Statement of Compliance Access for People with a Disability

Proposed Residential Development

54-58 Beaconsfild St Newport

Report Type: Statement of Compliance - BCA Access Provisions

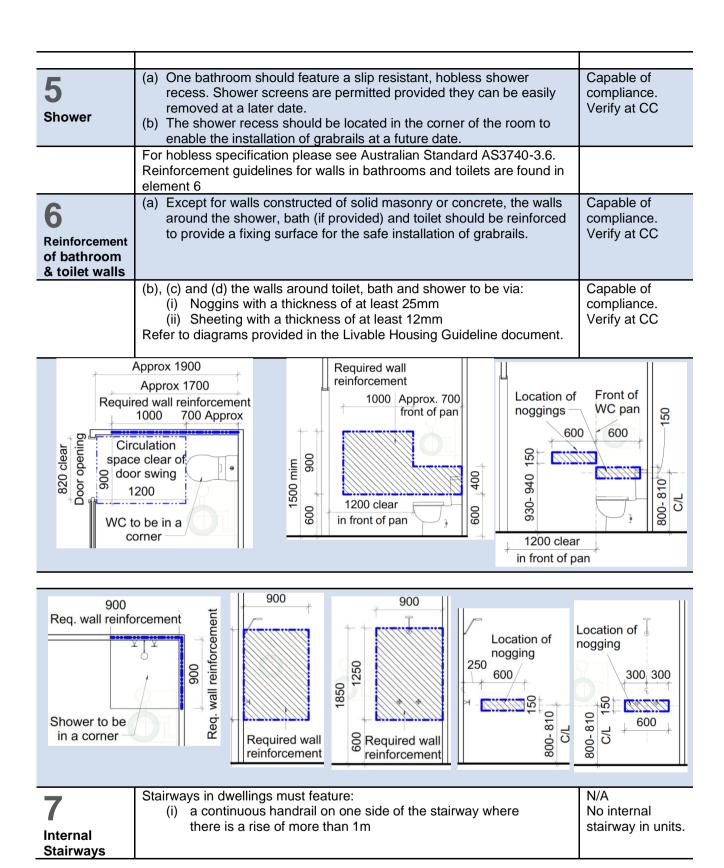
Total number of residential units in the development = 20% of 13 = 2.6 = 3 required Livable units.

the following 3 units G03, 102 & 202 are capable of providing compliance with the features of Silver level of Livable Housing Guidelines as noted in the table below.

By incorporating the requirements of the below Checklist in the Specifications of the project, the nominated Livable units can achieve full compliance with Livable Housing Guidelines- Silver Level
